Access Audit Site Report

Palmetto State Park

Accessibility Evaluation

Inspection Date: 02/10/2022

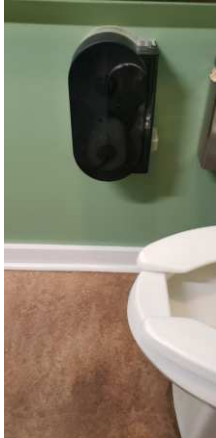
Finding Number	Area Description	Lat/Long	Finding	As Built	Recommendation	Citation	Photos	Figure
23	Headquarters (HQ) : HQ - Employee Spaces	[29.5969112, -97.5851467]	The operable part is positioned too high for either a side or front approach. Where a clear floor or ground space allows a parallel approach to an element and the side reach is unobstructed, the high side reach shall be 48 inches maximum and the low side reach shall be 15 inches minimum above the finish floor or ground. Where a forward reach is unobstructed, the high forward reach shall be 48 inches maximum and the low forward reach shall be 15 inches minimum above the finish floor or ground.	lights and keypad 51" AFF, lock box 58" AFF over safe	Remount operable parts to be in reach range of 15" min to 48" max	2015 ABAAS Section: 308.1 2012 TAS Section: 308.1 2010 ADAS Section: 308.1		
24	Headquarters (HQ) : HQ - Employee Spaces	[29.596938, -97.5851681]	Minimum maneuvering clearances at doors and gates shall comply with 404.2.4. Maneuvering clearances shall extend the full width of the doorway and the required latch side or hinge side clearance. Maneuvering clearances shall have a max slope of 2.08%. Door openings shall provide a clear width of 32 inches (815 mm) minimum. Clear openings of doorways with swinging doors shall be measured between the face of the door and the stop, with the door open 90 degrees. Openings more than 24 inches (610 mm) deep shall provide a clear opening of 36 inches (915 mm) minimum. There shall be no projections into the required clear opening width lower than 34 inches (865 mm) above the finish floor or ground. Projections into the clear opening	Rear door - 4" change in level at door, 30" wide, trash stored in pull side clearance, knob hardware, 6" step to door	For all doors along the public circulation route, provide required maneuvering clearance on push and pull side of doors. For all doors along the public circulation route, replace doors with doors having 80" overhead clearance and 32" clear width. For all doors along the public circulation route, repair, bevel, or ramp CILs at door entries to max .25". Provide a ramp for access. For all doors along the public circulation route, replace hardware with lever hardware or hardware operable without a tight pinch or grasp.	2010 ADAS Section: 404.2.3, 404.2.7, 404.2.4, 404.2.11, 404.2.11 Exception

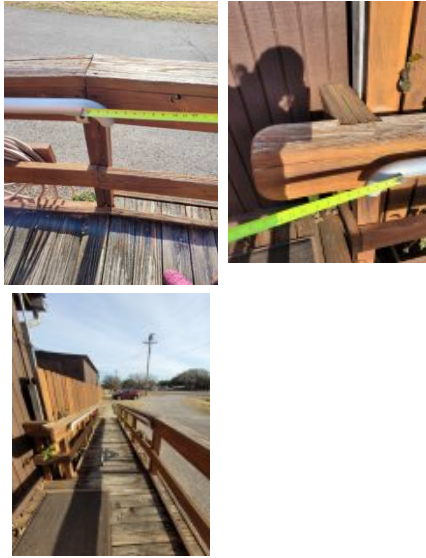
Finding Number	Area Description	Lat/Long	Finding	As Built	Recommendation	Citation	Photos	Figure
25	Headquarters (HQ) : HQ - Employee Spaces	[29.5970103 , -97.585185 6]	Picnic tables shall provide at least one wheelchair space for each 24 linear feet (7320 mm) of usable table surface perimeter. Wheelchair spaces shall be 30 inches (760 mm) minimum by 48 inches (1220 mm) minimum. Wheelchair spaces shall be positioned for a forward approach to the table and provide knee and toe clearance complying with 306 under the table	non accessible picnic table on rear side of HQ	Replace picnic table with one of an accessible design as a smart practice	2015 ABAAS Section: 1011.4.2		
26	Headquarters (HQ) : HQ - Employee Restroom	[29.5969404 , -97.585162 8]	The restroom sign does not comply with one or more applicable requirements for the location, height, and properties of the sign.	no signage	Acquire and mount signage, including Braille, raised lettering and access symbol mounted on wall, latch side of door, 48" to baseline of lowest character and 60" to baseline of highest character	2015 ABAAS Section: F216.2, 703.1, 703.2, 703.5, 703.6 2012 TAS Section: 216.2, 703.1, 703.2, 703.5, 703.6 2010 ADAS Section: 216.2, 703.1, 703.2, 703.5, 703.6

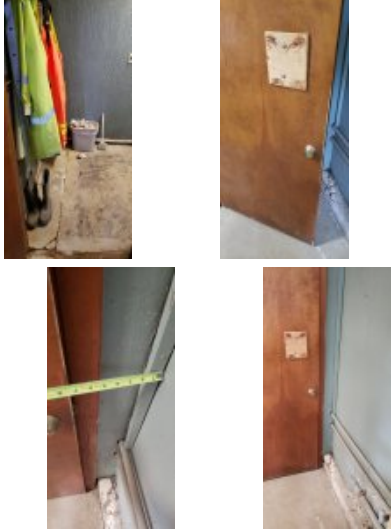
Finding Number	Area Description	Lat/Long	Finding	As Built	Recommendation	Citation	Photos	Figure
30	Headquarters (HQ) : HQ - Employee Restroom	[29.596924, -97.585164 1]	The side grab bars are not in the correct location. Grab bars on the side wall must be installed so that the end closest to the rear wall is maximum 12" from the rear wall. The end furthest from the rear wall must be mounted minimum 54" from the rear wall.	36" bar, 48" from wall	Replace side grab bar with a 42" long bar mounted to max 12" from the rear wall at the close end and min 54" on the far end, and 33" to 36" aff.	2015 ABAAS Section: 604.5.1 2012 TAS Section: 604.5.1 2010 ADAS Section: 604.5.1		
31	Headquarters (HQ) : HQ - Employee Restroom	[29.5969392, -97.585152]	The grab bar height and/or spacing fails. Grab bars must be mounted between 33" and 36" to the top of the gripping surface. There must be 1.5" of clearance between the grab bar and the wall. There must be a minimum of 1.5" of clearance below and minimum 12" above the grab bar to any dispenser or other obstruction.	toilet 1" below bar, spray can stored on bar	Remount grab bar and remove storage to provide min 12" above or 1.5" below grab bar.	2015 ABAAS Section: 609.3, 609.4 2012 TAS Section: 609.4, 609.3 2010 ADAS Section: 609.3, 609.4

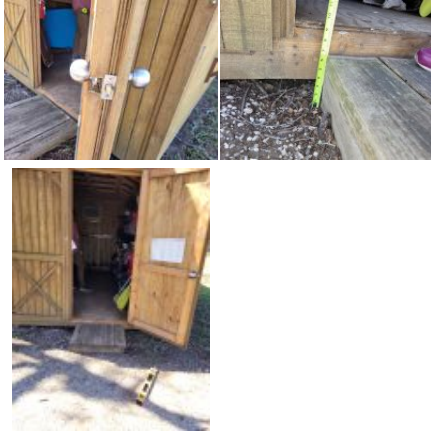
Finding Number	Area Description	Lat/Long	Finding	As Built	Recommendation	Citation	Photos	Figure
51	Headquarters (HQ) : Ice Cooler	[29.5972296 , -97.5850206]	The ramp on the accessible route contains cross slopes greater than 2%. Surface cross slopes shall not exceed one unit vertical in 48 units horizontal (2-percent slope).	ramp to ice machine - 2.3% cross slope	Correct ramp cross slope to max 2.08%. Cost included in previous finding.	2015 ABAAS Section: 405.3 2012 TAS Section: 405.3 2010 ADAS Section: 405.3		
52	Headquarters (HQ) : Ice Cooler	[29.5972354 , -97.5850152]	The ramp does not have compliant handrails. Handrails are required on both sides of all surfaces that are sloped greater than 5 percent (1:20). Handrails must be between 34 inches and 38 inches above the ramp surface, must extend beyond the top and bottom of the ramp 12 inches and be parallel to the floor or ground surface. The diameter of the handrails must be between 1 inches and 2 inches in cross-sectional nominal dimension for circular handrails and handrail gripping surfaces with a non-circular cross section shall have a perimeter dimension of 4 inches minimum and 6 inches maximum, and a cross-section dimension of 2 inches maximum. The clear space between handrails and walls must 1-1/2 inches minimum.	ramp to ice machine - missing handrails	Install handrails that are rounded and/or extend to the ground, with handrail extensions and mounted 34" to 38" aff	2015 ABAAS Section: 505.1 2012 TAS Section: 505.1 2010 ADAS Section: 505.1

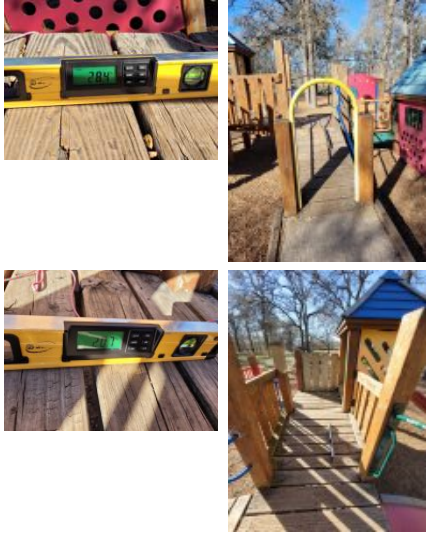
Finding Number	Area Description	Lat/Long	Finding	As Built	Recommendation	Citation	Photos	Figure
53	Park Site: Park Elements	[29.5969042 , -97.585068 9]	Element meets all standards and requirements	after hours self pay station complies	None	2010 ADAS Section: N/A		
54	Park Site: Park Elements	[29.5928227 , -97.586318 8]	An accessible access route is not provided between elements, spaces and the facilities provided within the accessible camping unit. At least one outdoor recreation access route shall connect accessible elements, spaces and facilities provided within camping units with mobility features.	no AR to 9 of 9 picnic tables by playground	Create AR with crushed and compacted stone or similar outdoor material to picnic area and replace two tables with ones of an accessible design	2015 ABAAS Section: F244.5.1		
55	Park Site: Park Elements	[29.5892355 , -97.583334 8]	An accessible access route is not provided between elements, spaces and the facilities provided within the accessible camping unit. At least one outdoor recreation access route shall connect accessible elements, spaces and facilities provided within camping units with mobility features.	no AR to picnic tables by refectory	Create AR with crushed and compacted stone or similar outdoor material to picnic area and replace two tables with ones of an accessible design.	2015 ABAAS Section: F244.5.1

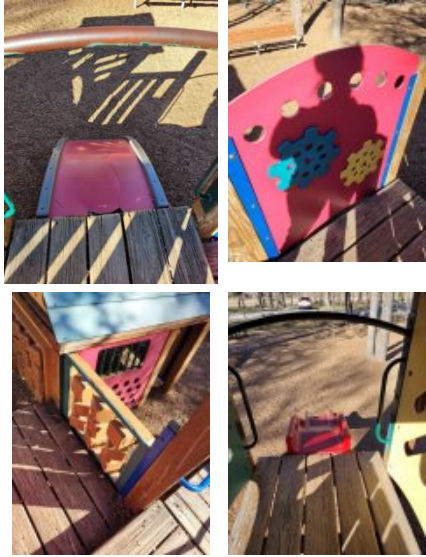
Finding Number	Area Description	Lat/Long	Finding	As Built	Recommendation	Citation	Photos	Figure
57	Park Site: Park Elements	[29.5898466 , -97.582287 4]	Water spouts at water hydrants and water utility hook-ups shall be 28 inches (710 mm) minimum and 36 inches (915 mm) maximum above the ground	dump station - water spout 53" AFF and no clear floor space	Remount water spouts to 28" min or 36" max above the ground as a smart practice	2015 ABAAS Section: 1011.6	 	
58	Park Site: Park Elements	[29.5892583 , -97.583601 5]	An accessible access route is not provided between elements, spaces and the facilities provided within the accessible camping unit. At least one outdoor recreation access route shall connect accessible elements, spaces and facilities provided within camping units with mobility features.	no AR to 5 of 5 picnic, 5 of 5 grills, 2 of 2 trash across from the refectory	Create AR with crushed and compacted stone or similar outdoor material to one picnic site and one of each type of amenity. Replace table and grill with ones of an accessible design and provide the required clear ground space.	2015 ABAAS Section: F244.5.1

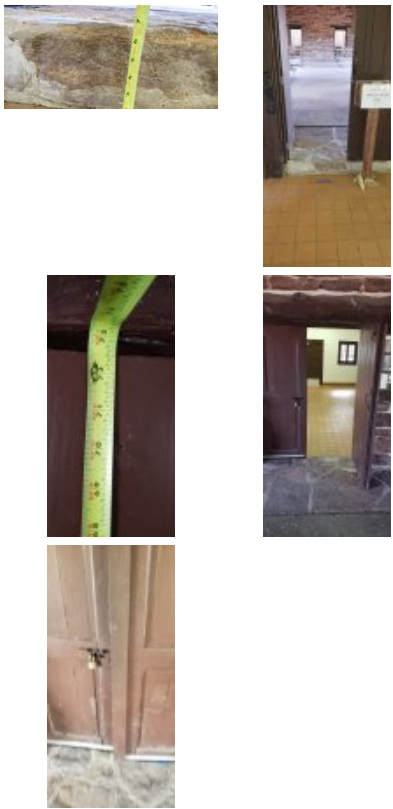
Finding Number	Area Description	Lat/Long	Finding	As Built	Recommendation	Citation	Photos	Figure
82	Refectory/ CCC Pavilion : Refectory - Parking	[29.5895492 , -97.583903 5]	The accessible route of travel contains cross slopes greater than 2%. Cross slopes shall not exceed one unit vertical in 48 units horizontal (2-percent slope).	3% slope at doorway entry to closed building portion of refectory	Correct or repair cross slope along AR to max 2.08%	2015 ABAAS Section: 403.3 2012 TAS Section: 403.3 2010 ADAS Section: 403.3		
83	Refectory/ CCC Pavilion : Refectory - Parking	[29.5894583 , -97.583969 2]	The accessible route contains loose gravel and/or surface materials that do not provide for a stable, firm slip resistant surface. Floor and ground surfaces shall be stable, firm, and slip resistant.	no AR to refectory due to rock surface, not deteriorated but too bumpy	Create route adjacent to existing rock path with crushed and compacted stone or similar outdoor material from parking or sidewalk to the building.	2015 ABAAS Section: 302.1 2012 TAS Section: 302.1 2010 ADAS Section: 302.1

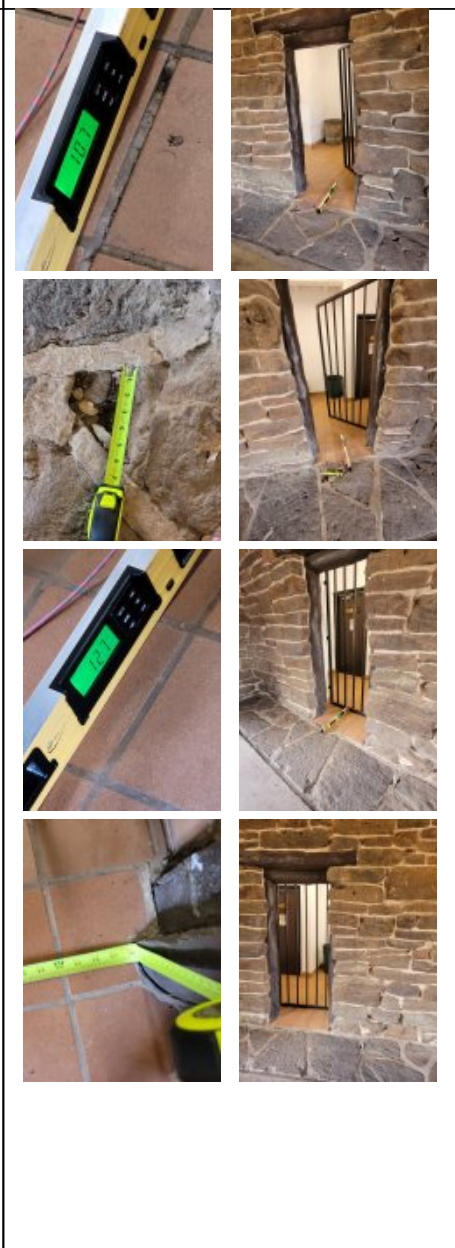
Finding Number	Area Description	Lat/Long	Finding	As Built	Recommendation	Citation	Photos	Figure
87	Refectory/ CCC Pavilion : Refectory - Public Spaces	[29.5896087 , -97.583875 3]	There is a gap spaced greater than a 1/2 inch. Openings in floor or ground surfaces shall not allow passage of a sphere more than 1/2 inch diameter. Elongated openings shall be placed so that the long dimension is perpendicular to the dominant direction of travel.	1.5" gap around paved center, 4" gap around exterior picnic area	Correct or fill gaps to be max .5".	2015 ABAAS Section: 302.3 2012 TAS Section: 302.3 2010 ADAS Section: 302.3

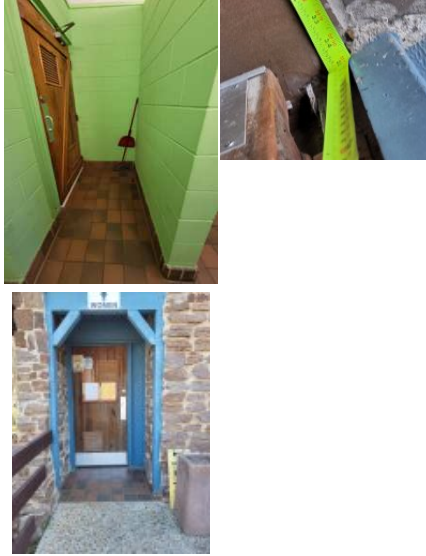
Finding Number	Area Description	Lat/Long	Finding	As Built	Recommendation	Citation	Photos	Figure
154	Campground 1-19 Loop : 1-19 Women's Restroom	[29.5897393 , -97.582314 3]	There is no hand held sprayer unit. The sprayer unit must have a 59 inches hose and be mounted 48 inches maximum to the top of mounting bracket off the floor. The shower spray unit shall have an on/off control with a non-positive shutoff. If an adjustable-height shower head on a vertical bar is used, the bar shall be installed so as not to obstruct the use of grab bars.	no hose, affixed shower head is 52" aff	Replace shower control with a compliant lever control with a shower head on a 59" hose and usable as hand held or remount fixed shower head to max 48" AFF.	2015 ABAAS Section: 608.6 2012 TAS Section: 608.6 2010 ADAS Section: 608.6		<p>SHOWER SPRAY UNIT</p>  <p>Water Temperature: 120° F Max.</p> <p>Top of mounting bracket: 48" Max. above the shower floor.</p> <p>©Builder's Book, Inc.</p>

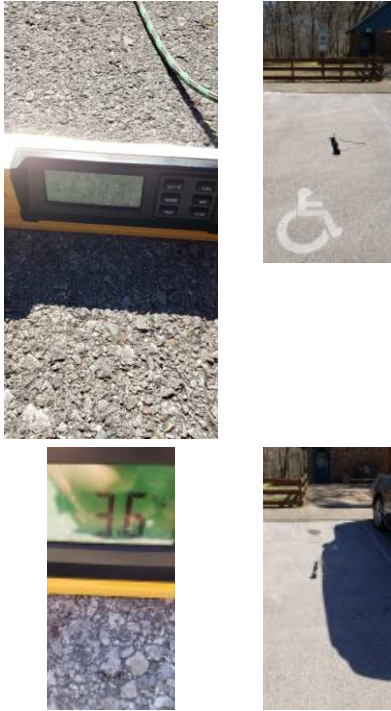
Finding Number	Area Description	Lat/Long	Finding	As Built	Recommendation	Citation	Photos	Figure
160	Campground 1-19 Loop : 1-19 Women's Restroom	[29.5897113 , -97.5823143]	The ambulatory stall is not between 35" to 37" wide and 60" deep.	Ambulatory stall 38" wide	Correct ambulatory stall to be 35" to 37" wide and minimum 60" deep. In the alternative, use existing stall to create required wheelchair stall.	2015 ABAAS Section: 604.8.2.1 2012 TAS Section: 604.8.2.1 2010 ADAS Section: 604.8.2.1		
161	Campground 1-19 Loop : 1-19 Women's Restroom	[29.58973, -97.5823518]	The toilet is not located within the range to the side wall or partition. The centerline of the toilet shall be 17 inches minimum and 19 inches maximum side wall or partition in the ambulatory accessible toilet compartment.	toilet centerline 20" from green wall	Remount toilet to 17" to 19" from the side wall to center line in ambulatory stalls or 16" to 18" in wheelchair stall.	2015 ABAAS Section: 604.9.1 2012 TAS Section: 604.9.1 2010 ADAS Section: 604.9.1

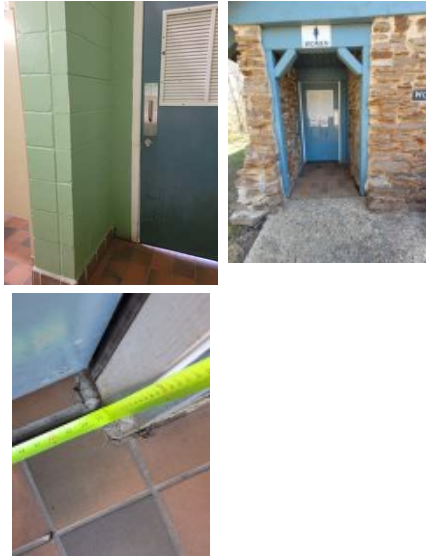
Finding Number	Area Description	Lat/Long	Finding	As Built	Recommendation	Citation	Photos	Figure
183	Campground 20-40 Loop : 20-40 Men's Restroom	[29.59293, -97.58549]	Minimum maneuvering clearances at doors and gates shall comply with 404.2.4. Maneuvering clearances shall extend the full width of the doorway and the required latch side or hinge side clearance. Maneuvering clearances shall have a max slope of 2.08%. Door openings shall provide a clear width of 32 inches (815 mm) minimum. Clear openings of doorways with swinging doors shall be measured between the face of the door and the stop, with the door open 90 degrees. Openings more than 24 inches (610 mm) deep shall provide a clear opening of 36 inches (915 mm) minimum. There shall be no projections into the required clear opening width lower than 34 inches (865 mm) above the finish floor or ground. Projections into the clear opening width between 34 inches (865 mm) and 80 inches (2030 mm) above the finish floor or ground shall not exceed 4 inches (100 mm). Exterior doors are recommended to be maintained at 8.5 lbf as a smart practice. Force is to be measured at the operating hardware or 30 inches from the hinges, whichever is greater.	Door - wall 9" in pull side clearance, 48" deep recession and door only 33.5" wide, 8lbf push	For all doors along the public circulation route, provide required maneuvering clearance on push and pull side of doors. For all doors along the public circulation route, replace doors with doors having 80" overhead clearance and 36" clear width for recessed doors. For all doors along the public circulation route, inspect, adjust, and maintain 8.5 lbf to open exterior doors as a smart practice.	2010 ADAS Section: 404.2.3, 404.2.7, 404.2.4, 404.2.11, 404.2.11 Exception

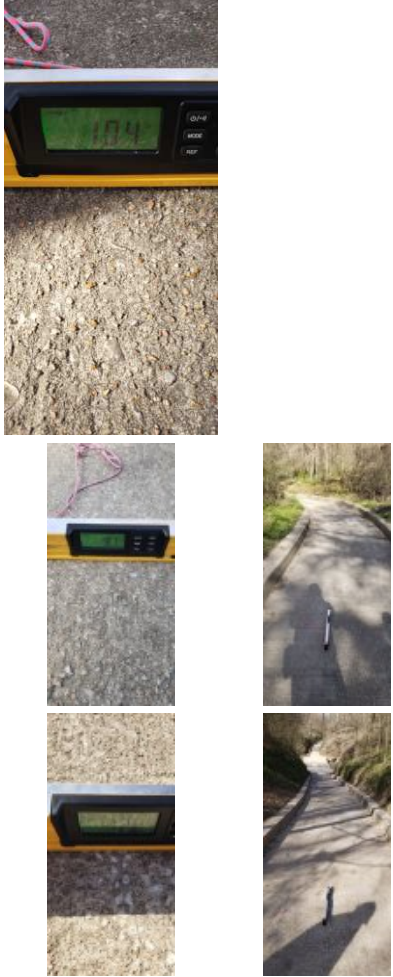
Finding Number	Area Description	Lat/Long	Finding	As Built	Recommendation	Citation	Photos	Figure
213	Campsites/ Cabins: Cabin	[29.5927994 , -97.587338]	The ceiling extends down too close to the route of travel. Any obstruction that overhangs a route of travel must be a minimum of 80 inches above the walking surface as measured from the bottom of the obstruction.	porch ceiling is 73.5" AFF	Raise porch ceiling to min 80", or pad object to prevent hazard in overhead clearance	2015 ABAAS Section: 307.3 2012 TAS Section: 307.3 2010 ADAS Section: 307.3		
214	Campsites/ Cabins: Cabin	[29.5928029 , -97.587347 4]	The ramps slope exceeds the maximum running slope (direction of travel) allowable of 8.33%. Ramps should have the least possible slope but in no case more than 8.3% (1:12).	9.3% slope at top, 9.1% slope at middle	Correct slope of ramp to max 8.33%.	2015 ABAAS Section: 405.2 2012 TAS Section: 405.2 2010 ADAS Section: 405.2

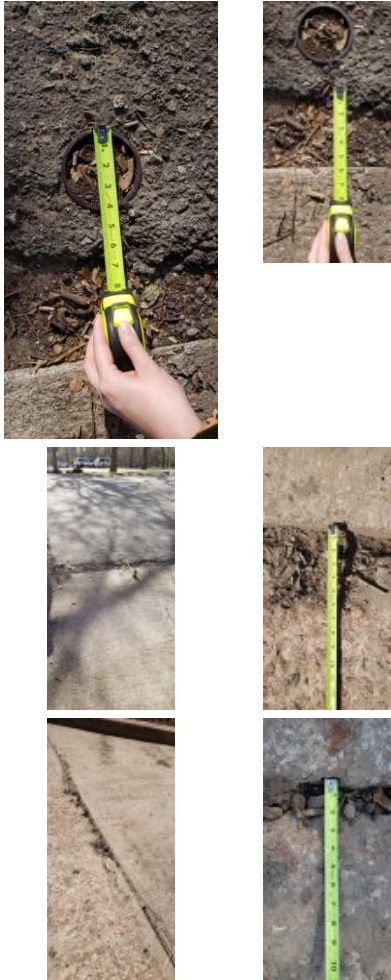
Finding Number	Area Description	Lat/Long	Finding	As Built	Recommendation	Citation	Photos	Figure
215	Campsites/ Cabins: Cabin	[29.5927854 , -97.587308 5]	The ramp does not have compliant handrails. Handrails are required on both sides of all surfaces that are sloped greater than 5 percent (1:20). Handrails must be between 34 inches and 38 inches above the ramp surface, must extend beyond the top and bottom of the ramp 12 inches and be parallel to the floor or ground surface. The diameter of the handrails must be between 1 inches and 2 inches in cross-sectional nominal dimension for circular handrails and handrail gripping surfaces with a non-circular cross section shall have a perimeter dimension of 4 inches minimum and 6 inches maximum, and a cross-section dimension of 2 inches maximum. The clear space between handrails and walls must 1-1/2 inches minimum.	guard rail only	Install handrails that are rounded and/or extend to the ground, with handrail extensions and mounted 34" to 38" aff	2015 ABAAS Section: 505.1 2012 TAS Section: 505.1 2010 ADAS Section: 505.1
